ASSESSMENT REPORT

110-114 HERRING ROAD, MACQUARIE PARK MP 10 0112 MOD 8 and MP 10 0113 MOD 8

Figure 3: Approved access driveway (left) and proposed access driveway (right) (Source: Proponent)

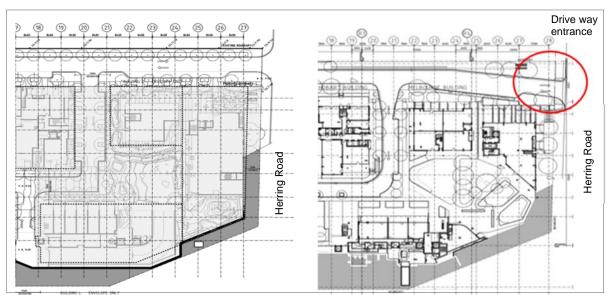
- modify Term of Approval A2 of the Concept Approval and Condition A2 of the Project Approval to amend the approved plans in order to realign the vehicle access from Herring Road to retain Telstra's required access to the existing telecommunications pit within the footpath (Figure 3);
- modify Term of Approval A2 of the Concept Approval and Condition A2 of the Project Approval to amend the approved plans in order to widen the internal ring road to satisfy Fire Rescue NSW requirements; and
- modify the approved landscape concept and civil package to reflect the above changes.

The modification to the entry alignment off Herring Road is required to retain access to Telstra's existing telecommunications services. Telstra will not permit construction of the driveway in the approved location as it requires clear access for maintenance at all times. Further, the frequent vehicular movement in and out of the site would potentially impact on the safety of maintenance staff working on these assets. Accordingly, the Proponent seeks to move the vehicle entry point approximately five metres to the south.

The proposed design retains the gradients of the previous access arrangement but will increase in width from six metres to 7.5 metres to assist with vehicles negotiating the change on the internal road.

The widening of the internal ring road is required by Fire Rescue NSW to accommodate access for its fire truck emergency vehicles.

In relation to the design of the revised driveway, the Statement includes a swept path analysis that confirms the ability of the new entry design to accommodate the largest design vehicle expected on site (a 12.5 metre heavy rigid vehicle) and the safe operation of the driveway.

In relation to the proposed widening of the internal road, the Statement confirms the revised internal kerb permits full site access for emergency vehicles required by Fire Rescue NSW.

The proposed changes would result in the loss of five podium level vehicle parking spaces, leaving 14 podium car spaces. However, as noted in the Statement, the proposed remaining 14 podium car spaces satisfy the minimum requirement of seven visitor spaces and six car share spaces required by the Project Approval and the Stage 2 development consent granted by Council.

Based on the findings of the Statement, the Department is satisfied the realignment of the

vehicle access on Herring Road and widening of the internal ring road would not adversely impact on traffic, access or parking. The Department recommends Condition A2 of the Concept and Project Approvals be updated accordingly.
